City of Sandy

Planning Commission Meeting

5.1. Deer Meadows Subdivision

**PLANNING COMMISSION STAFF REPORT
TYPE III LAND USE PROPOSAL**

SHEET **C2** OF **8**

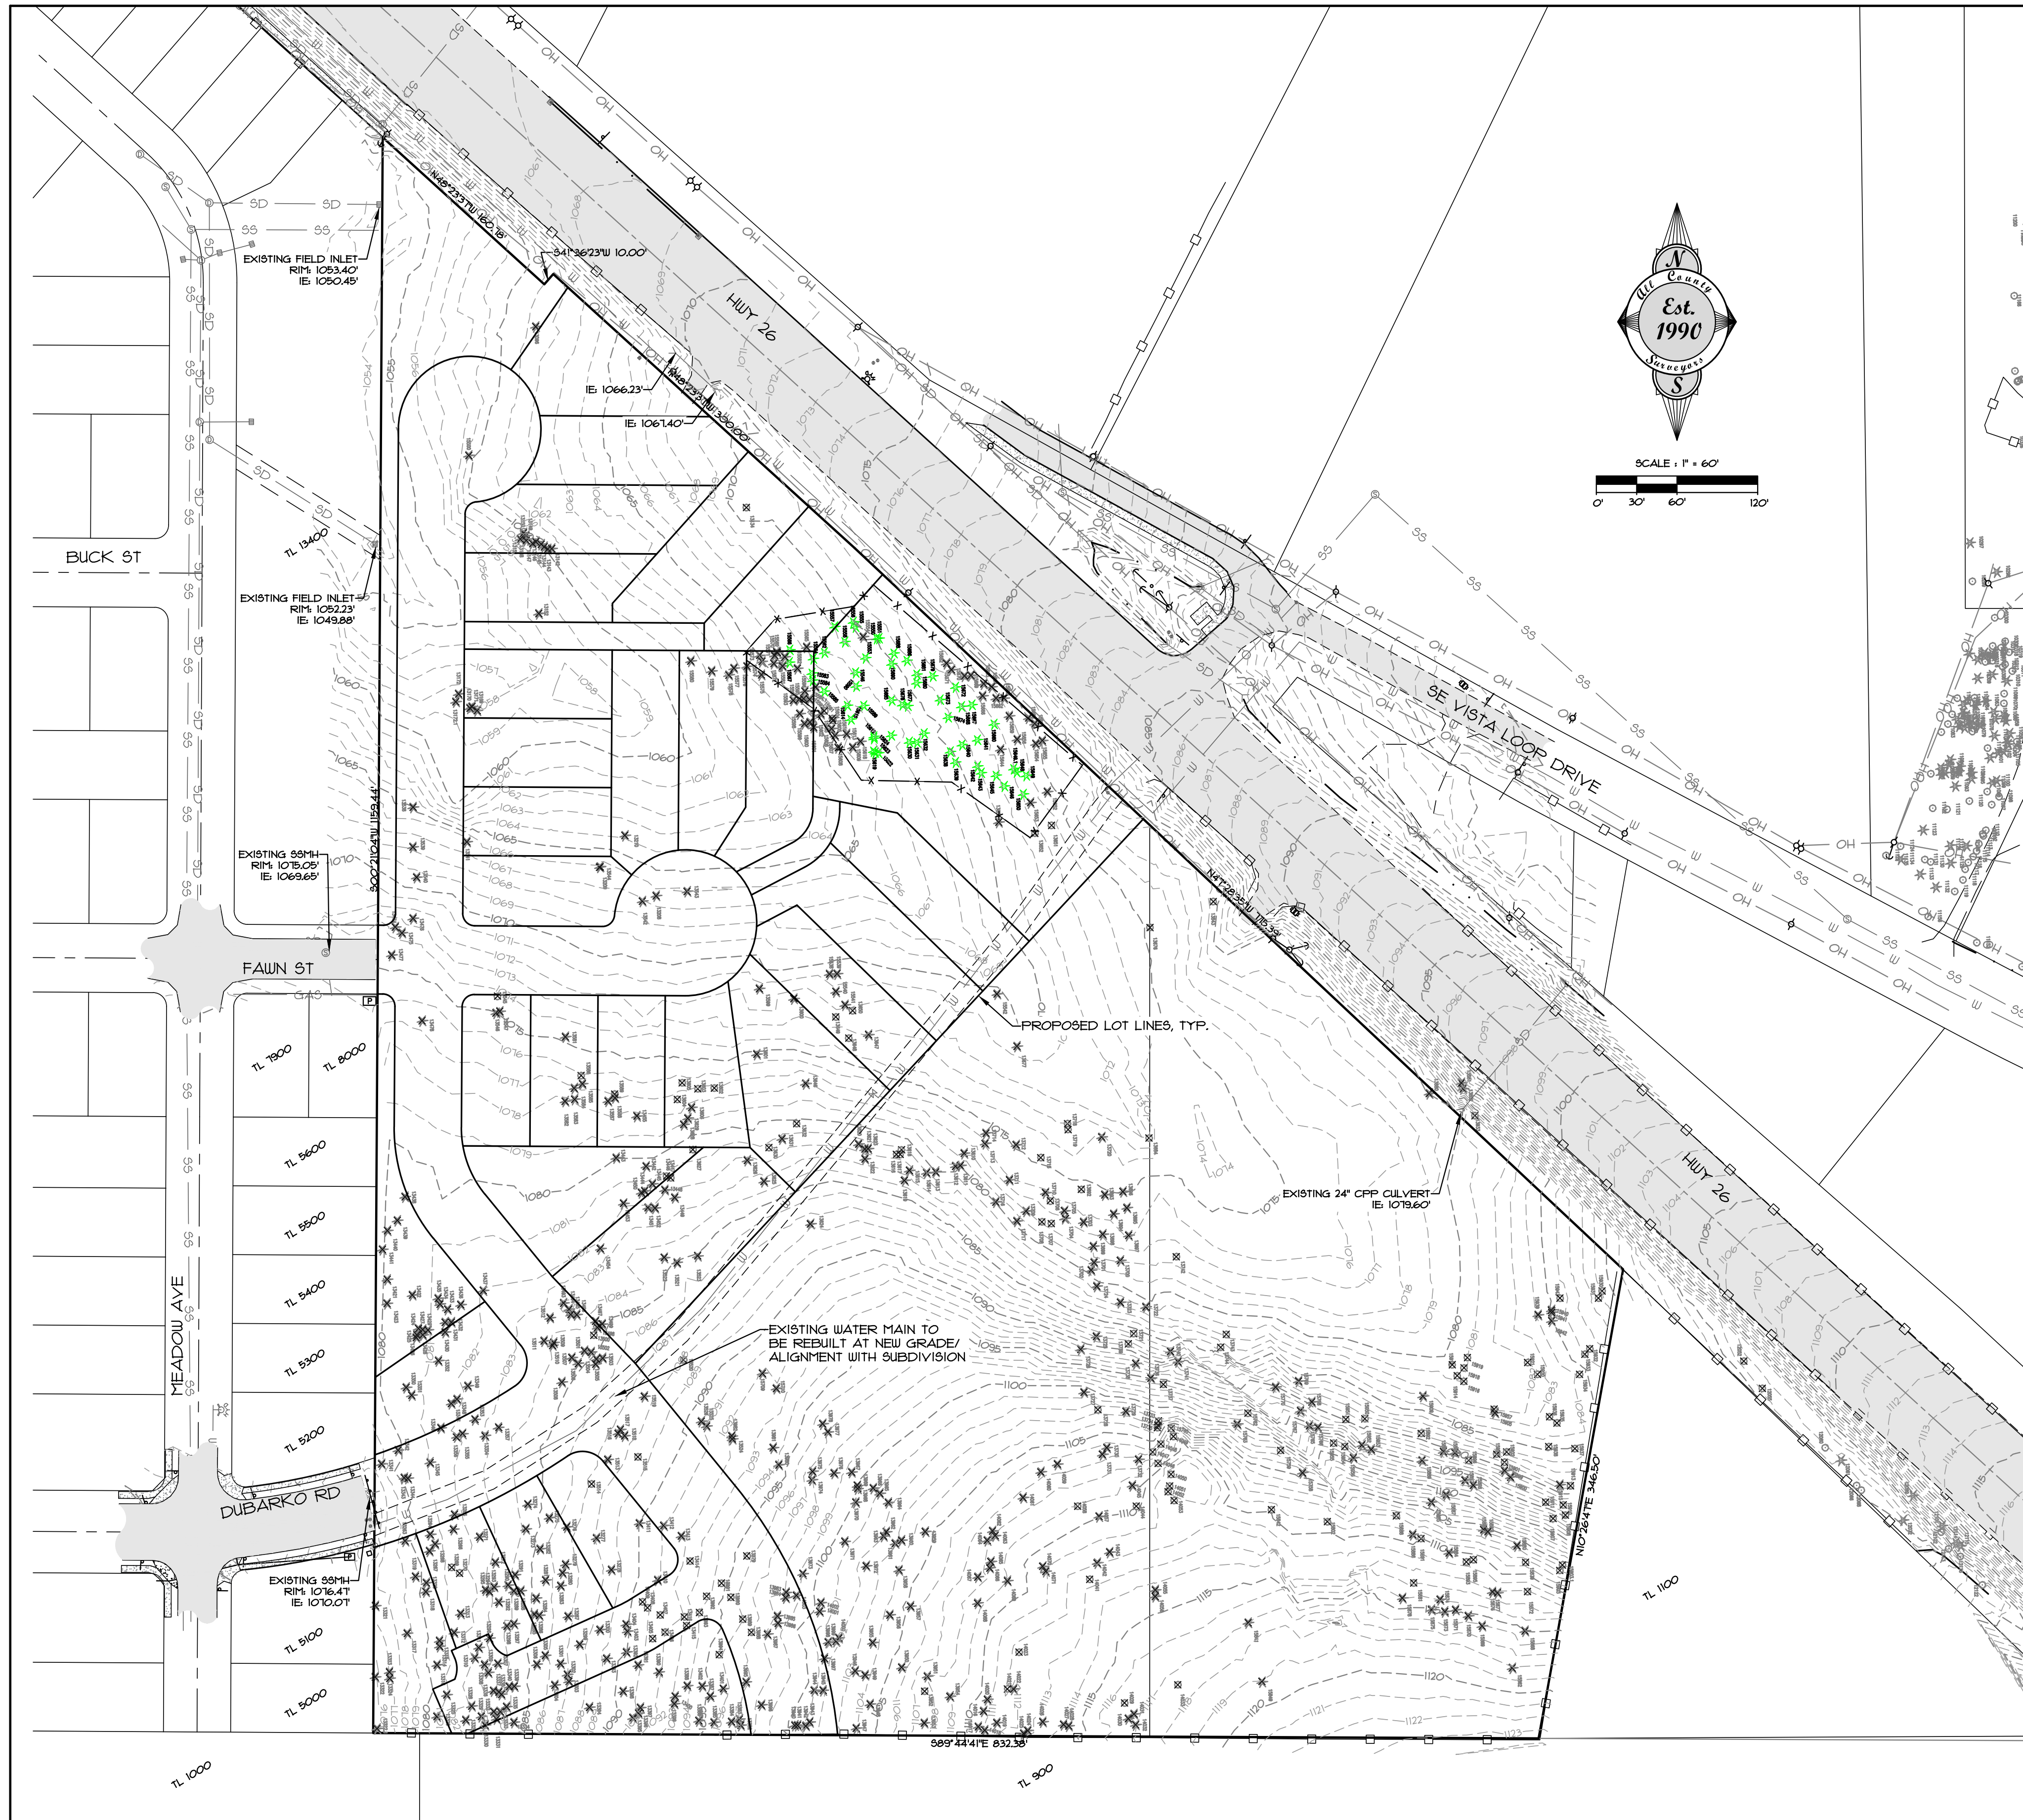
82. Most of the proposed retention trees are located along Highway 26 on Lot 13, which is proposed to be zoned R-1, Low Density Residential. As indicated on the Preliminary Plat (Exhibit C, Sheet C2), the applicant is proposing to place a conservation easement over an area that encompasses the retention trees on Lots 13, 14, and 21 totaling 21,939 square feet. Staff believes there could be a future conflict between retention trees in this conservation easement and development of Lot 13.

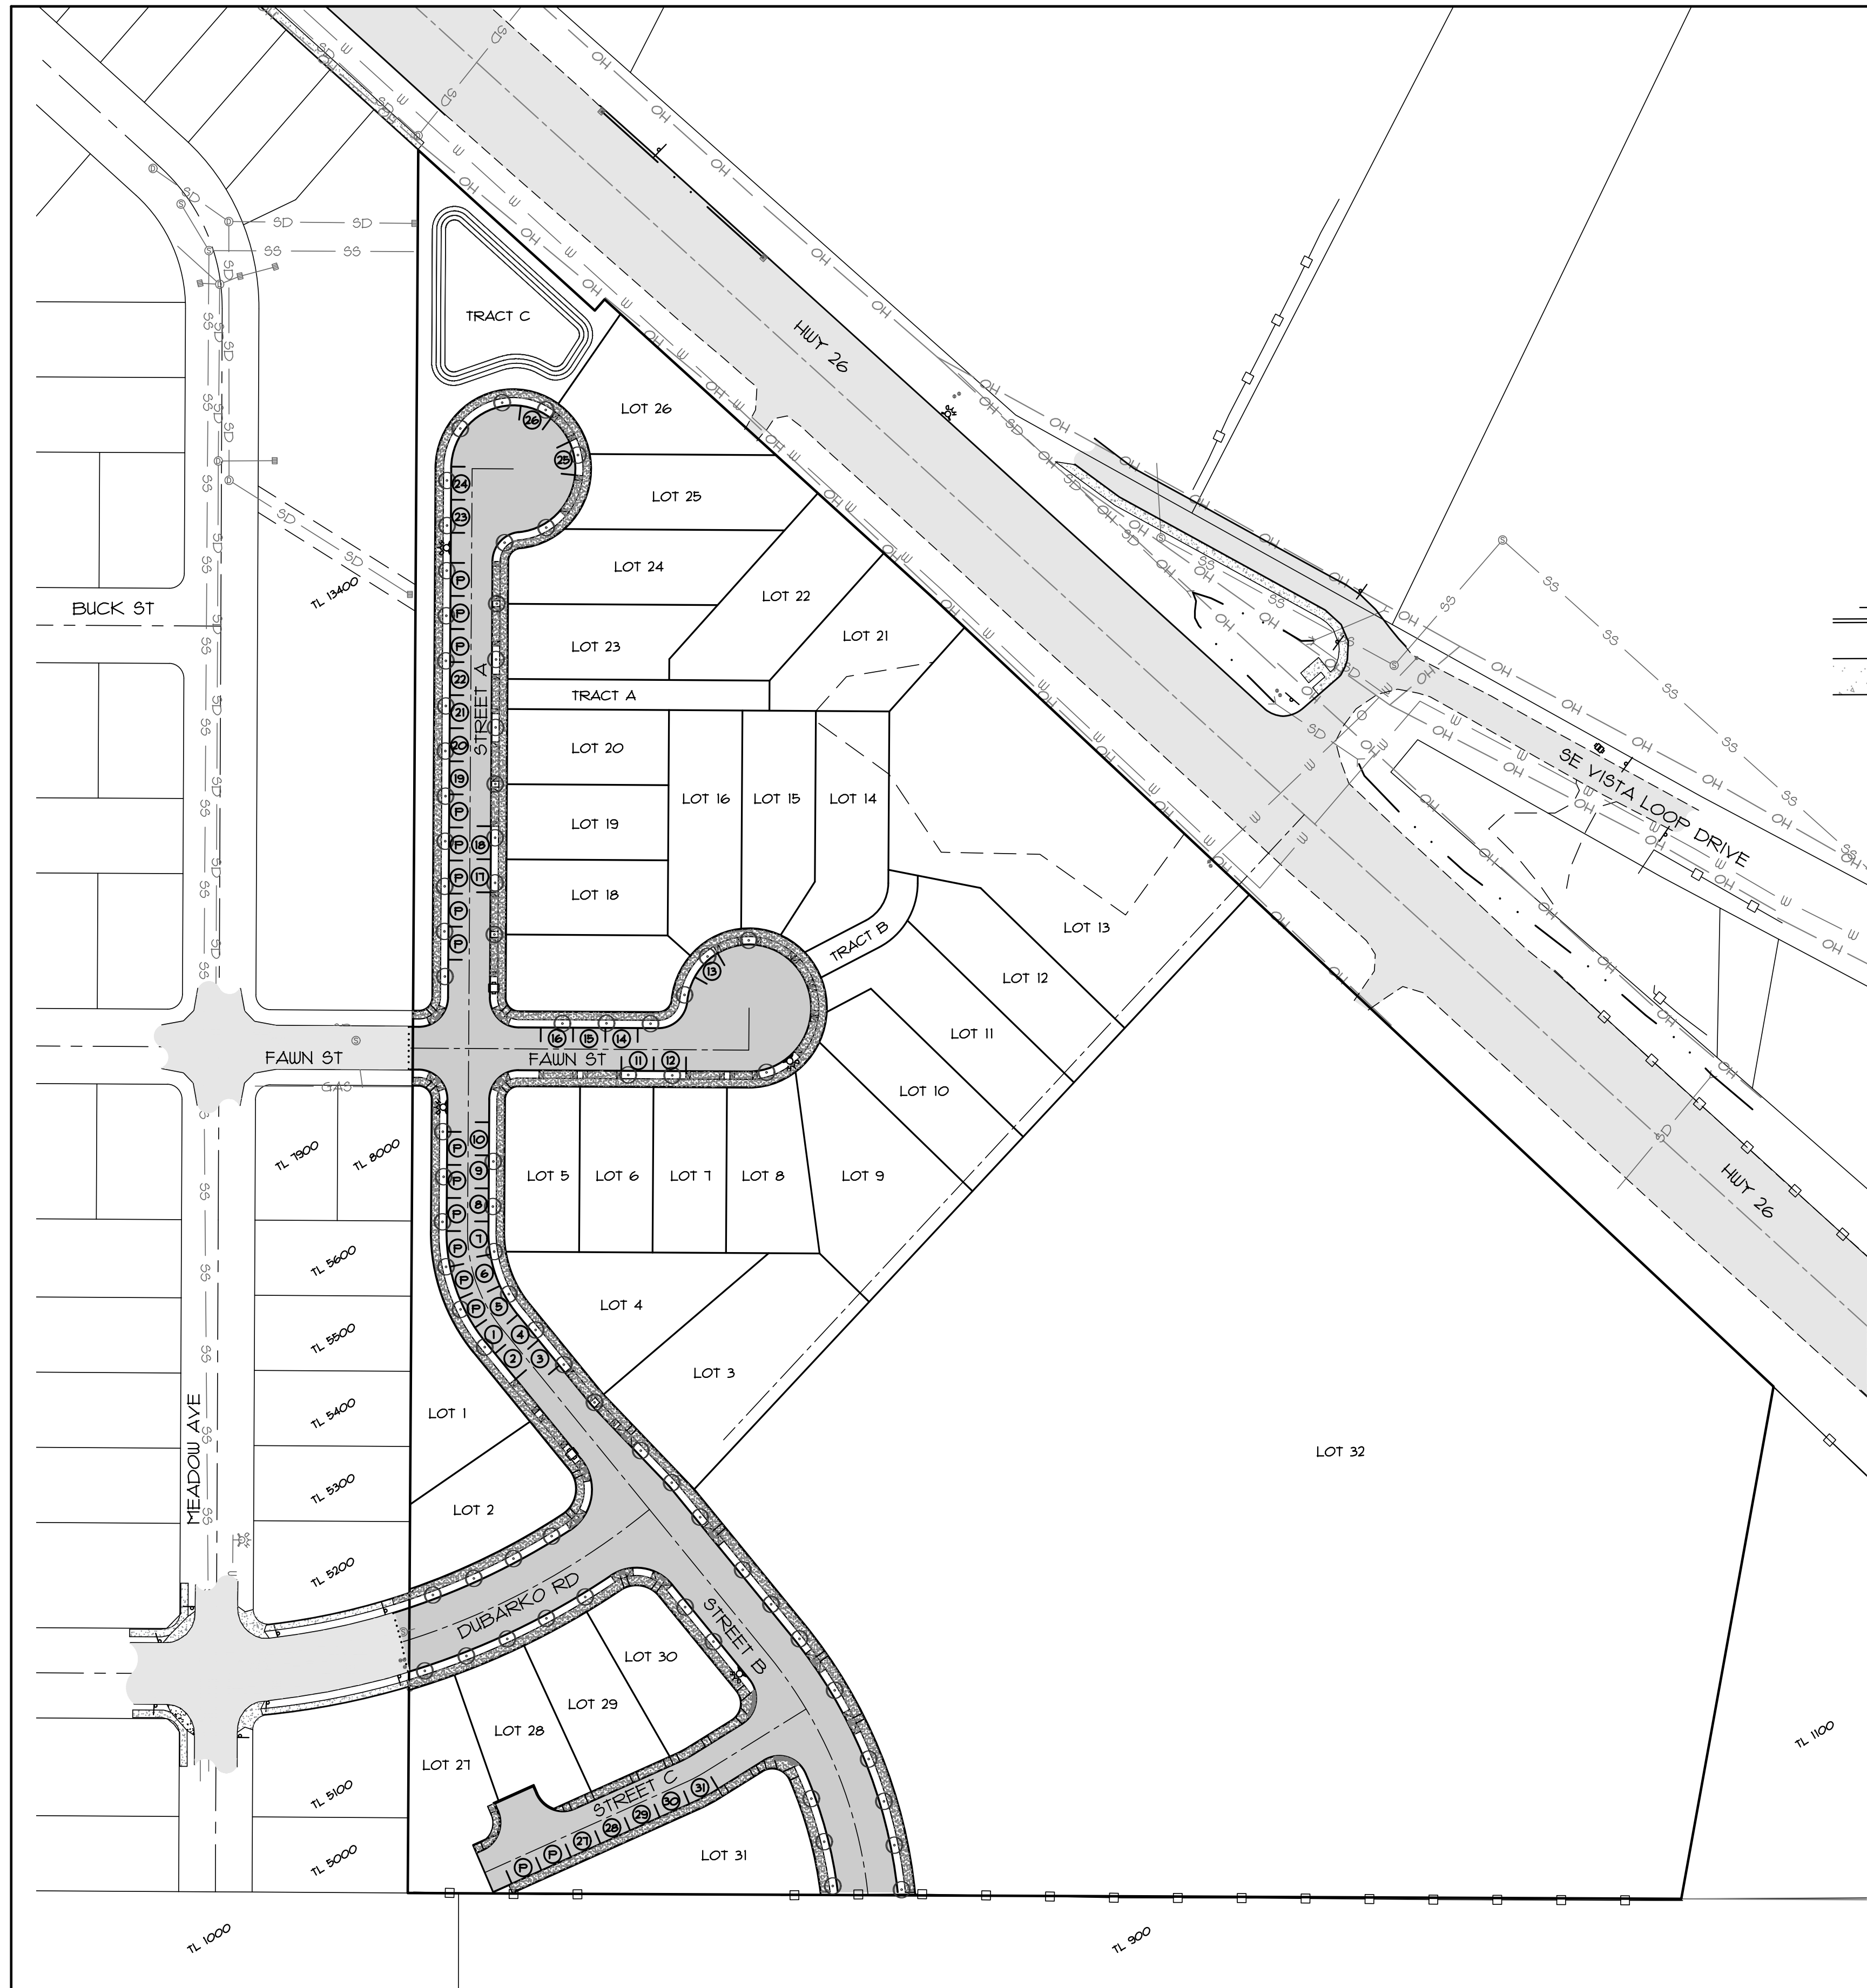
53. In relation to Sections 17.84.30(B), 17.84.30(C), 17.84.30(D), and 17.84.30(E), no pedestrian or bicycle facilities other than sidewalks have been identified or proposed in the subdivision. The plan set (Exhibit C, Sheet C5) does not identify bicycle lanes on Dubarko Road or Street B. **The applicant shall revise the plan set to include bicycle lanes on Dubarko Road and Street B.**

63. Section 17.84.60 outlines the requirements of public facility extensions. The applicant submitted a utility plan (Exhibit C, Sheet C5) which shows the location of proposed public water, sanitary sewer, and stormwater drainage facilities. **Broadband fiber service shall be detailed with construction plans.**

Sheet C5 of the applicant's submission contains a statement indicating that "Both of the proposed cul-de-sacs have less than 50% of their circumference covered by driveway drops". No dimensional information is shown on the site plan to support this statement. The location, number and width of all driveway approaches in cul-de-sacs shall not exceed the dimensional standards in section 17.98.100 SMC.
